KRAUS-ANDERSON® CONSTRUCTION COMPANY

ADDENDUM NO. 3

June 7, 2013

Duluth International Airport
New Parking Structure and Exterior Wayfinding Signage
Bid Package 2D
Duluth, MN 55811

**SECTION
DETAILS
SKYWALK**

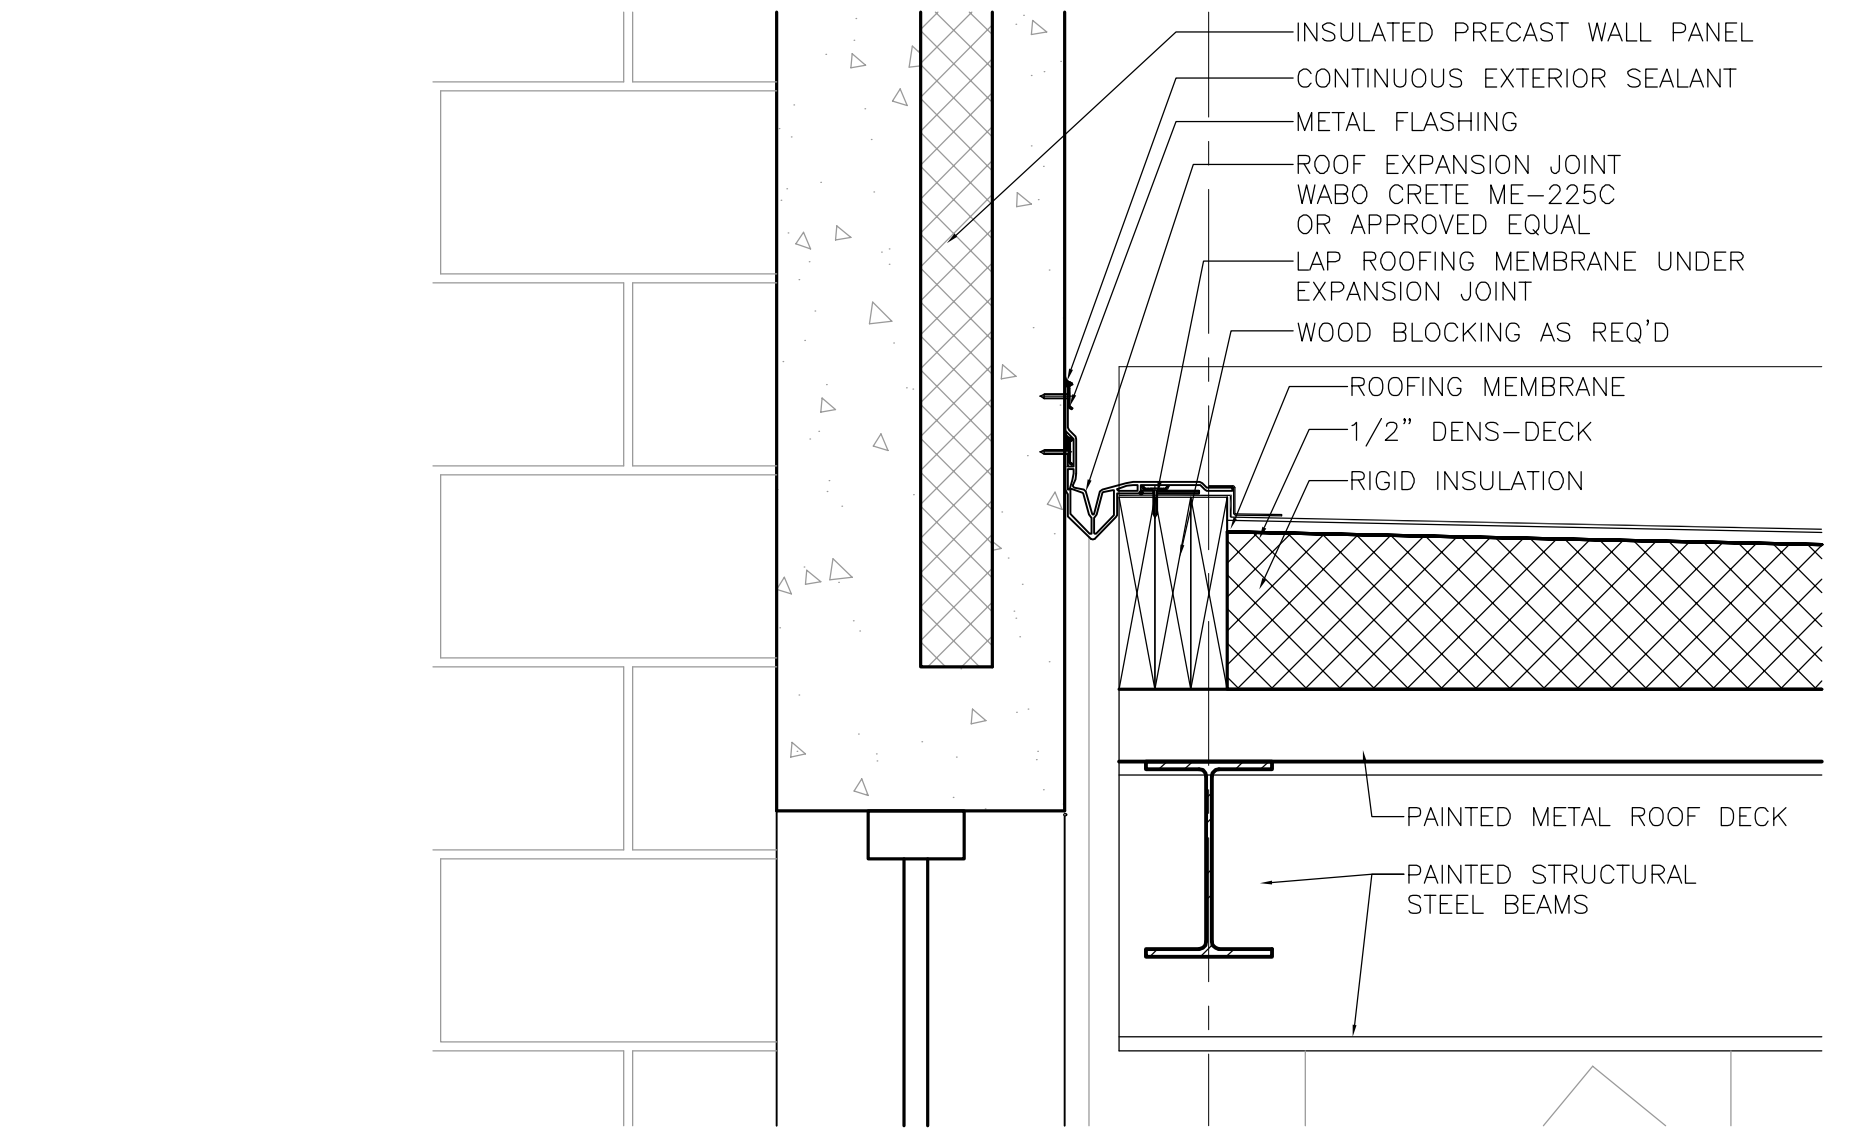
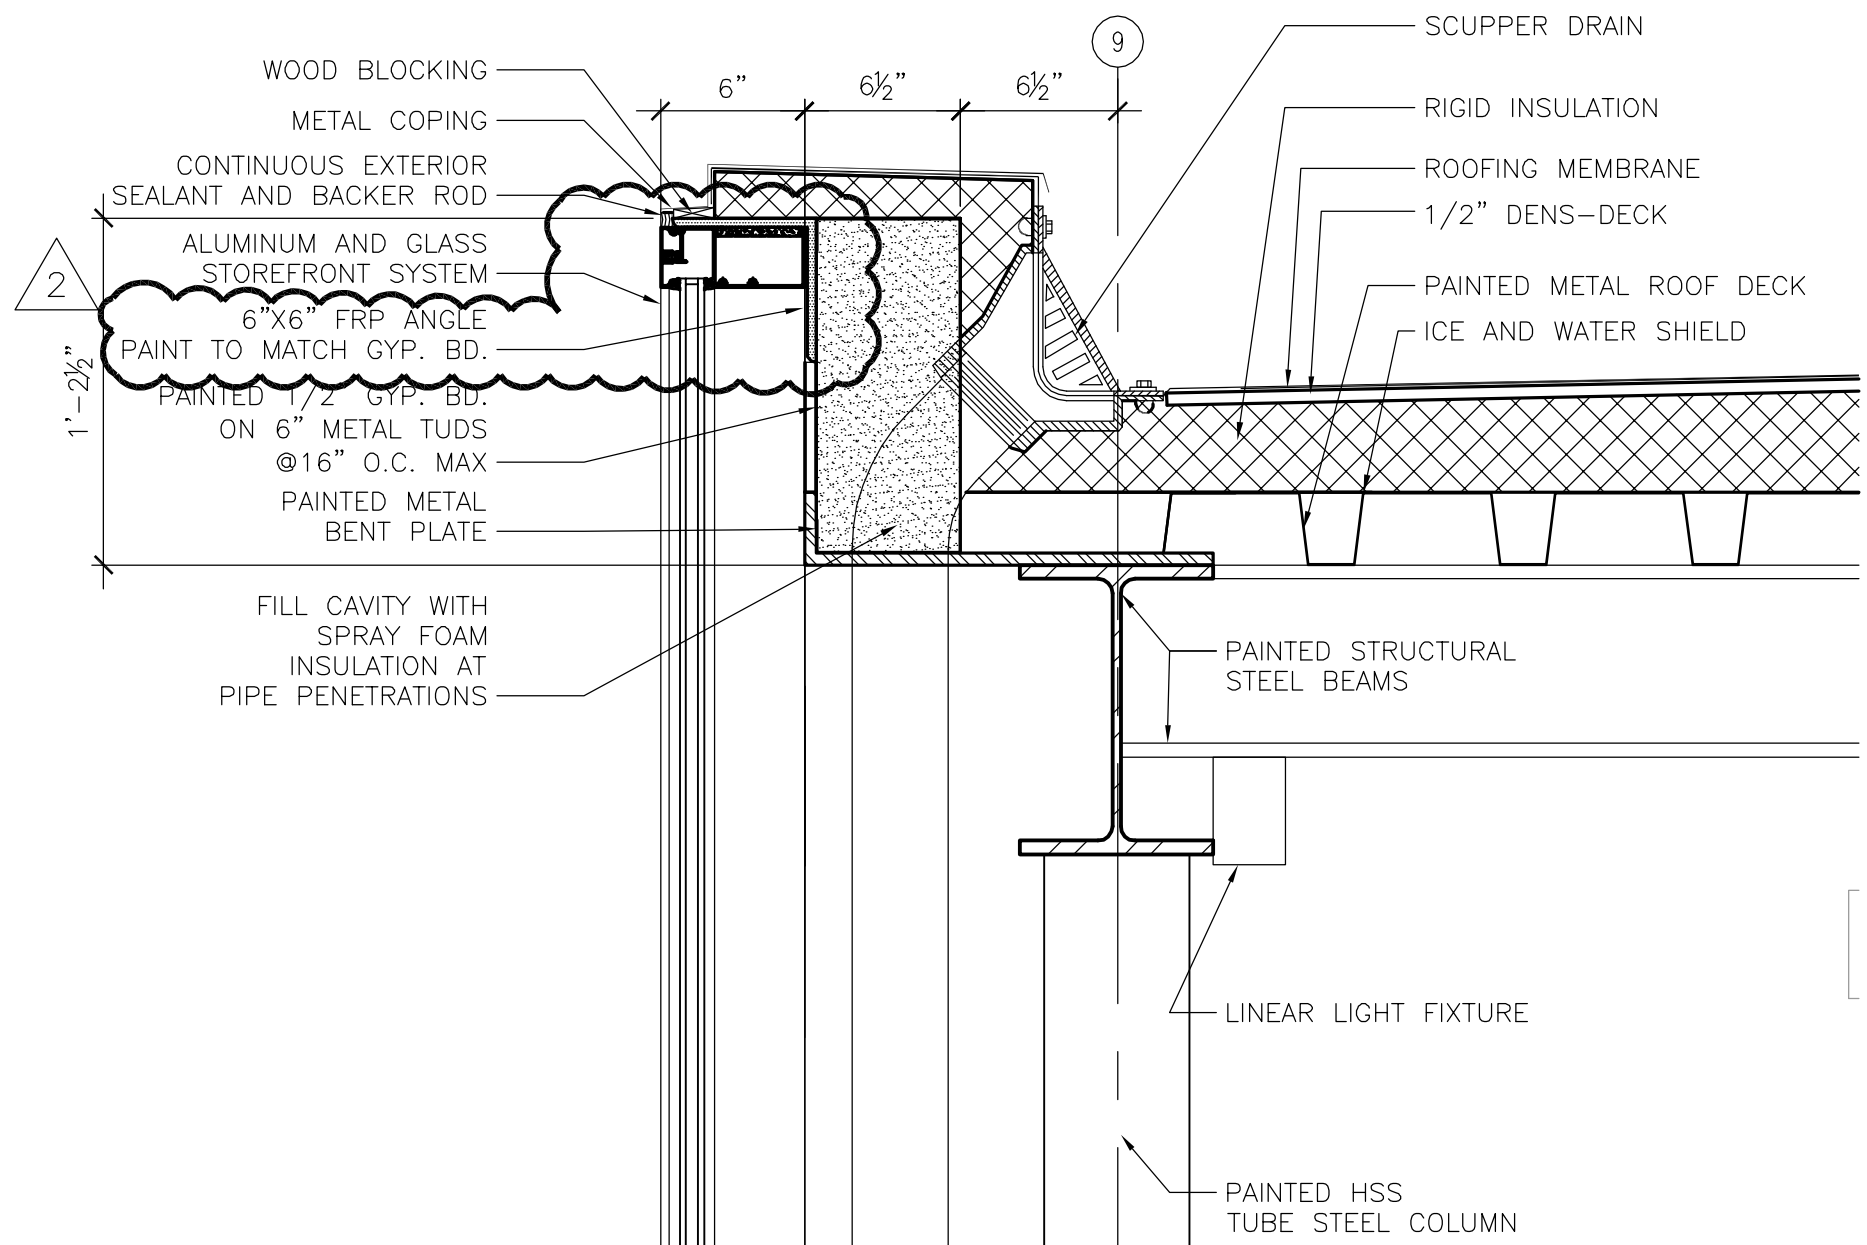
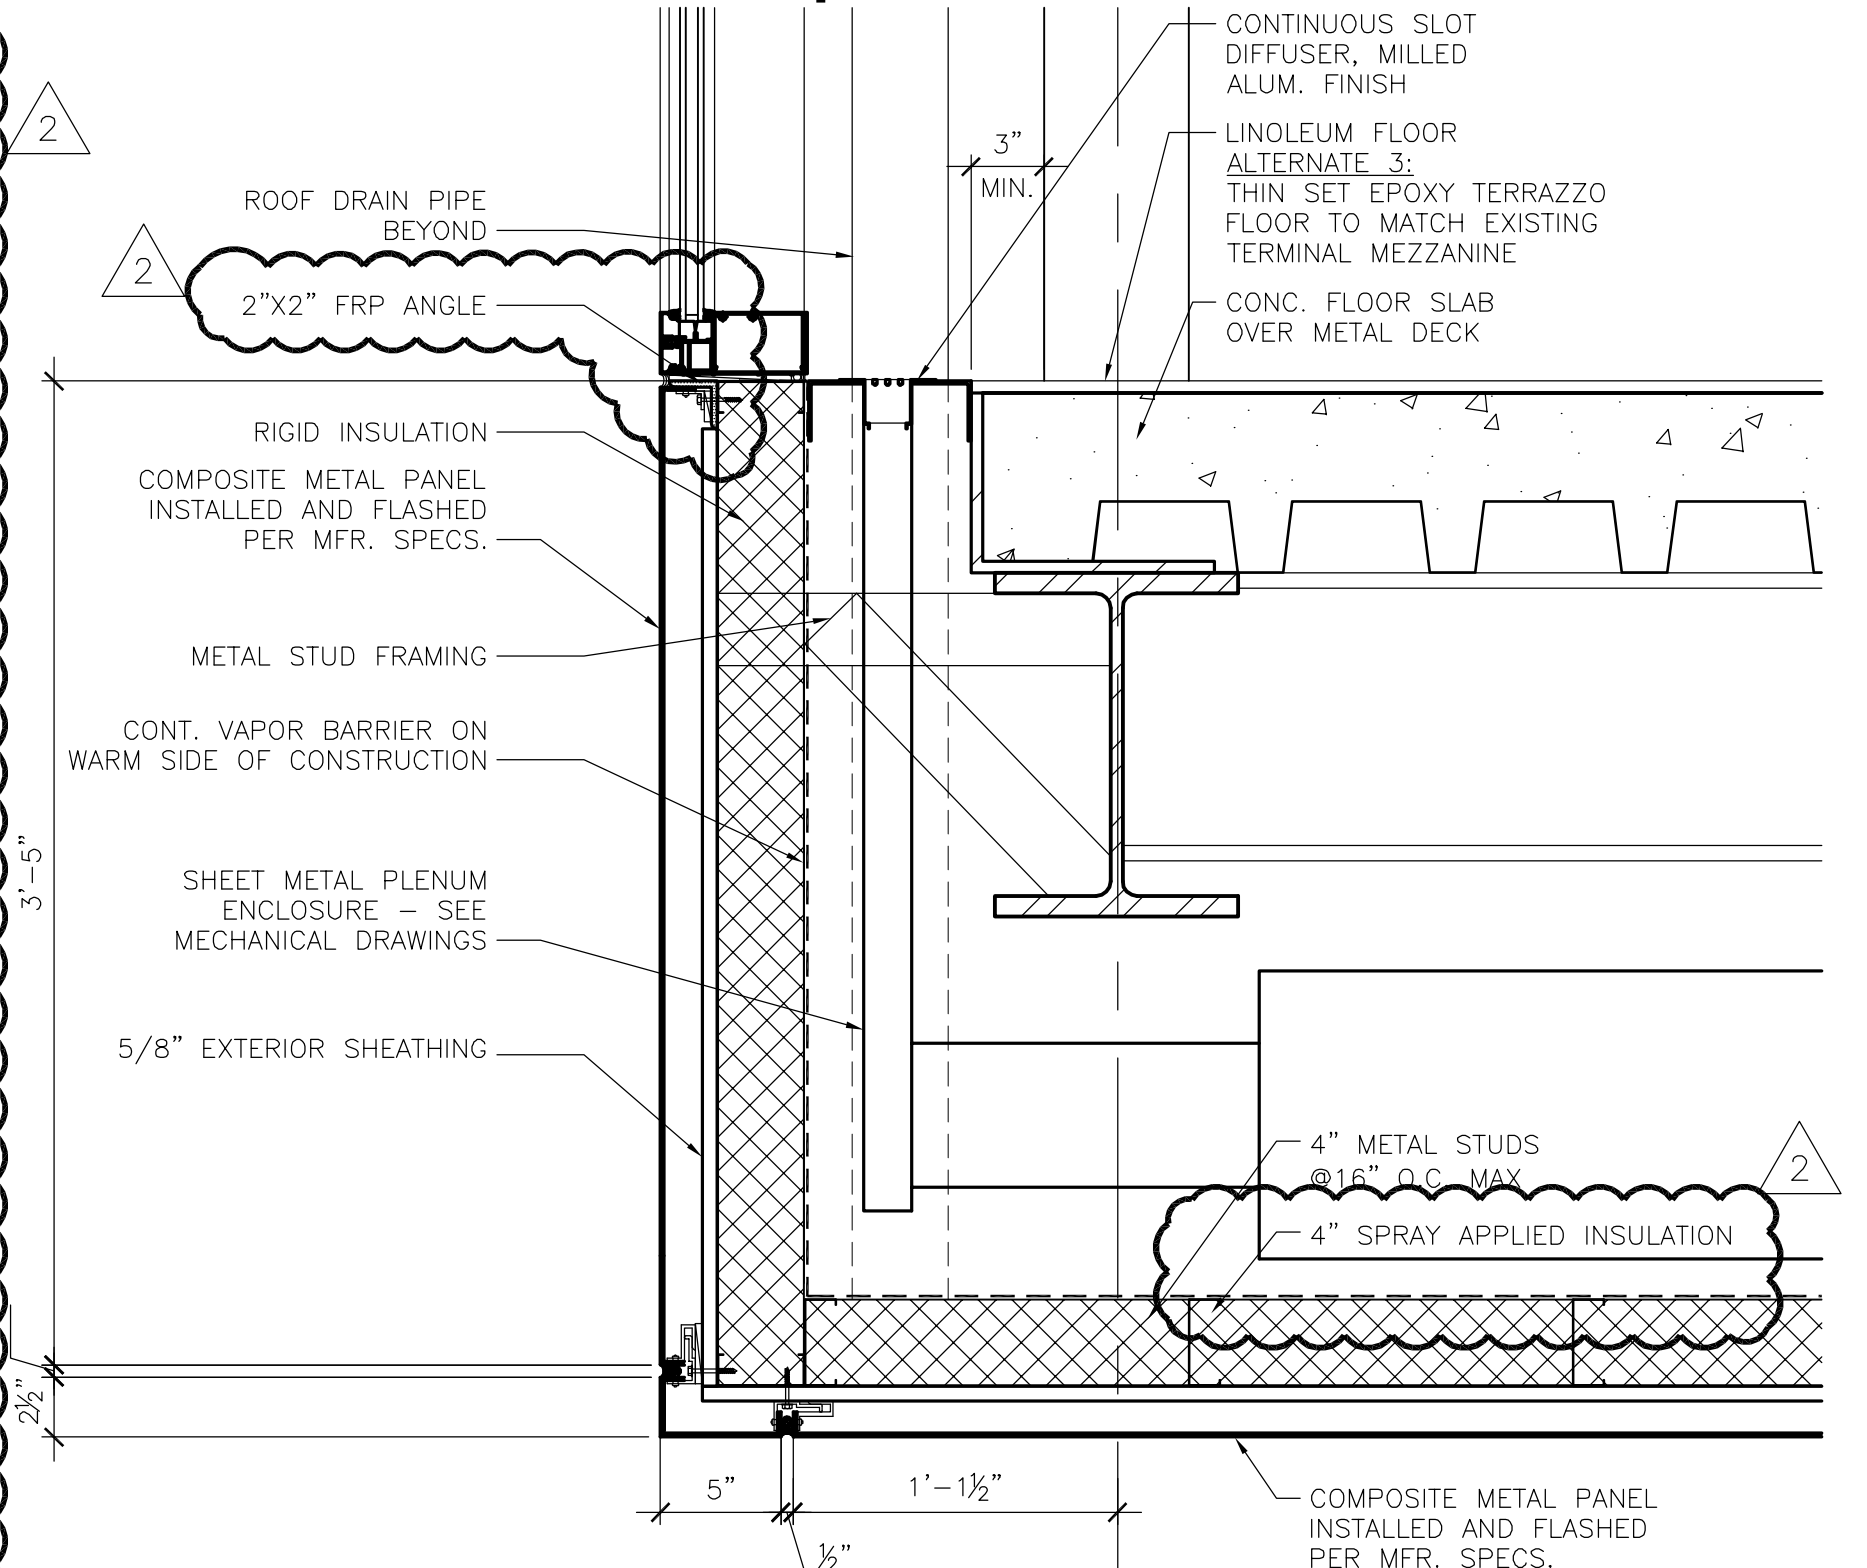
4.	WS 5.10D	Per the Work Scope 5.10D Item W, the architectural drawings do not have any detail that match the existing edge detail. I believe the architect should make a detail and add it to the bid documents.	Detail 6/A526 added to Addendum 3.
Sign Source, Inc.

6 SLAB EDGE DETAIL
1-1/2" = 1'-0"
